The Great Grid Upgrade

Norwich to Tilbury

Targeted consultation

Location reference: [Essex 13](#)

Area of proposed change February 2025

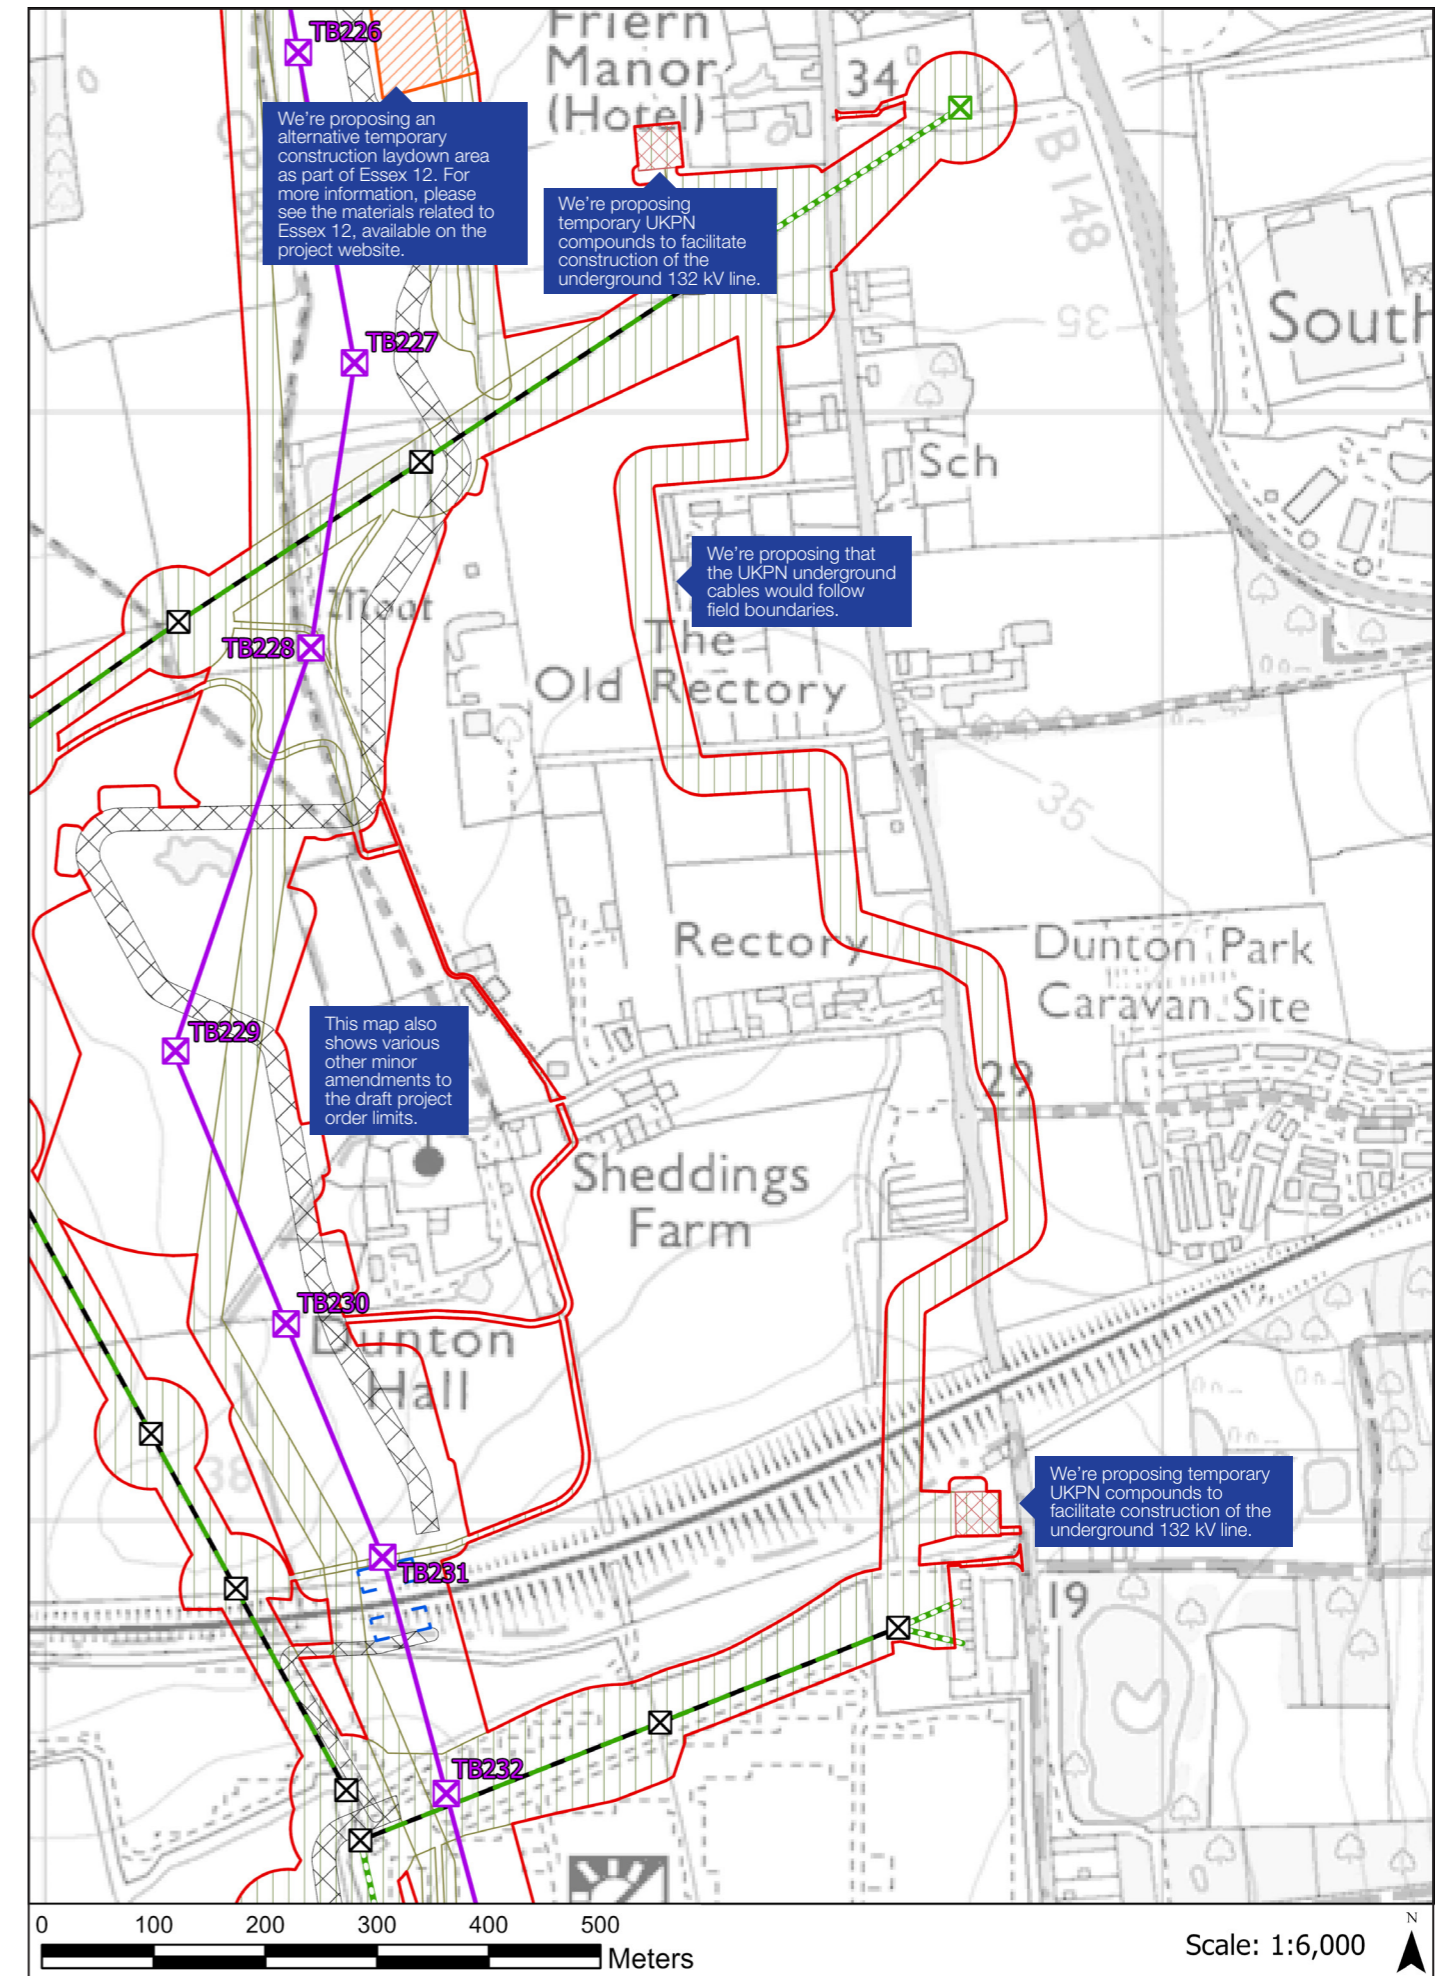
We are proposing to reposition the existing UK Power Networks (UKPN) 132 kV line close to Lower Dunton Road. This 132 kV connection is currently above ground and carried on lattice pylons but, to allow Norwich to Tilbury to come forward, it would need to be moved and placed underground. In our summer 2024 statutory consultation, we presented an underground route for the 132 kV connection. We are now proposing to reposition this underground route to follow more closely follow existing field boundaries on either side of Lower Dunton Road. You can see the alignment present at our statutory consultation in summer 2024 as well as our proposed changes on the maps overleaf.

To facilitate these works, we are also proposing temporary UKPN compounds at each end of the undergrounding route, which would be accessed via Lower Dunton Road. We are also proposing other minor amendments to the order limits.
